**CALIFORNIA COASTAL COMMISSION**

**STAFF REPORT: REGULAR CALENDAR****APPLICATION NO.: 4-98-143****APPLICANT: Patrica DUGGAN & Ted LEVENSON AGENT: Michael Barsocchini****PROJECT LOCATION: 24900 Pacific Coast Highway, Malibu (Los Angeles County)**

**PROJECT DESCRIPTION:** Construct 8,040 sq. ft., 18 foot high, one-story, single family residence with an attached 1,024 garage, tennis court, pool, spa, septic system and 1,180 cu. yds. of grading (390 cu. yds of cut & 790 cu. yds. of fill). An additional 230 cu. yds. of grading (100 cu. yds. of cut & 130 cu. yds. of fill) will be required for landslide slope remediation.

EXHIBIT NO. 2
APPLICATION NO.
4-98-143 (DUGGAN)
VIEW PROFILE

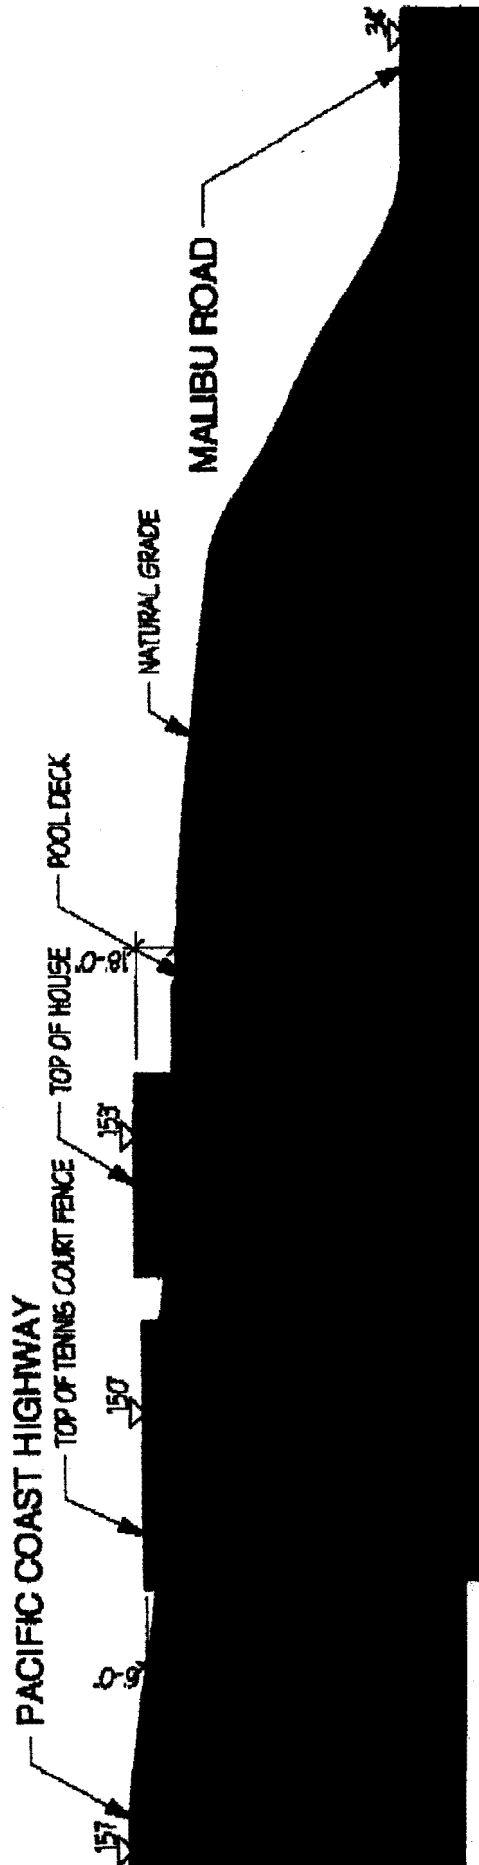
Geosoils, Inc. also indicates that the slope along the bluffs is unstable: "It is our opinion that the moderately steep slope descending to Malibu Road is surficially unstable. This is based on the presence of small landslides on the slope, as mapped and as discussed in item 4. The (recommended) setback zone will preclude development on or near the slope". Following the landslide on the bluffs that occurred during last winter's storm, as noted above, the consulting geologist revised the location of the recommended slope setback northward accordingly. The location of the proposed structures adhere to the revised, recommended slope setback, which is approximately 168 feet from the top of the slope (based on an average distance from the bluffs), as noted in Exhibit 2.

The subject site is located on a bluff top lot with a single family residence immediately to the east, the Malibu Jewish Center across Pacific Coast Highway to the north, a vacant lot to the west and numerous single family residences location across Malibu Road to the south. Staff requested that the applicant stake the site in order to assess the visual impact of the structure heights, including the tennis court fence, in the context of the bluewater views and the surrounding development. In addition, the applicant was required to graphically demonstrate the proposed structures would not significantly obscure the bluewater views from Pacific Coast Highway (see Exhibit 2).
